KEYSTONE ELECTRONICS CORP.			
www.keyelco.com • NEW HYDE PARK, NY 11040 • Tel (516) 328-7500			
PART NAME			
USB A-TYPE VERTICAL SOCKET			
MATERIAL			
AS NOTED			
FINISH		DRN BY	DATE
AS NOTED		BOONE	6.18.98
		APP'D	SCALE
		RH	2.5X
TOLERANCES	INCH [MM]	CODE	DWG NO.
DECIMAL	± .010 [± 0.25]	C	923
ANGULAR	± 1°		
UNLESS OTHERWISE SPECIFIED

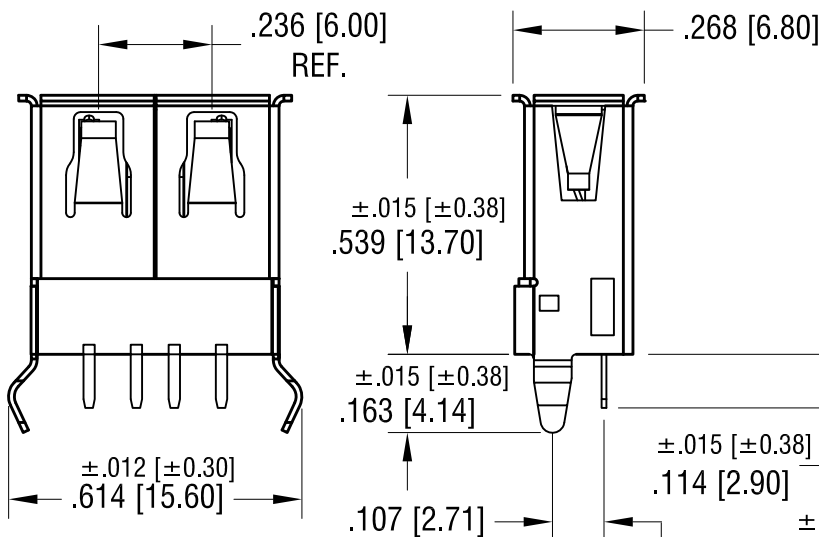
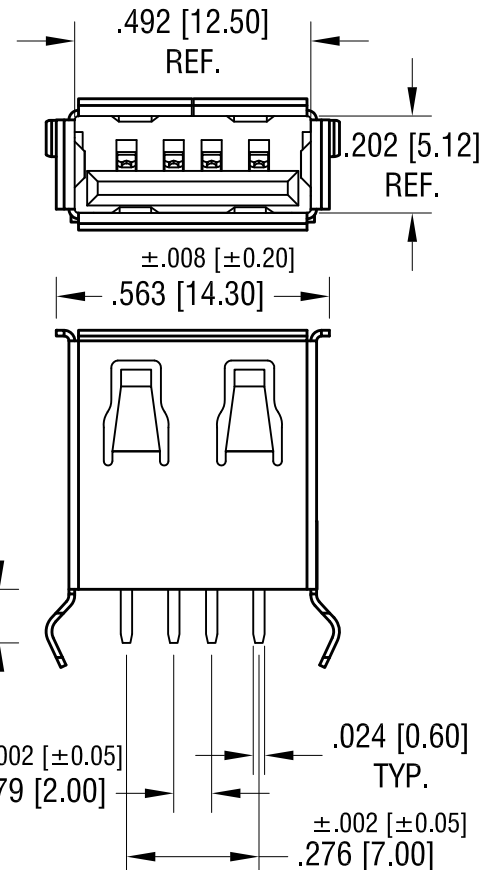
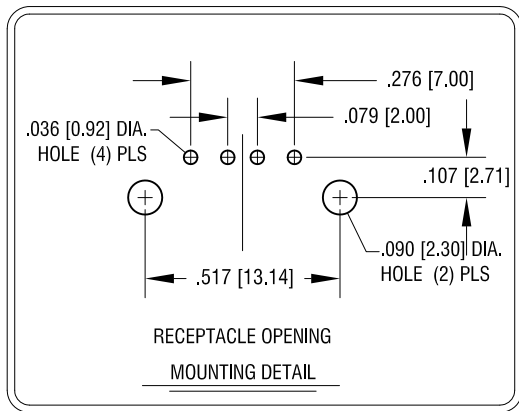
6.16.25	CHANGE AS PER PCN 25-031. SHELL MAT'L WAS BRASS.	L
5.07.25	(K1) WAS .084 [2.14] UPDATED MOUNTING DETAILS	K
3.20.25	UPDATED MAT'L&MOUNTING DETAILS. CHANGE AS PER ECN 25-087.	J
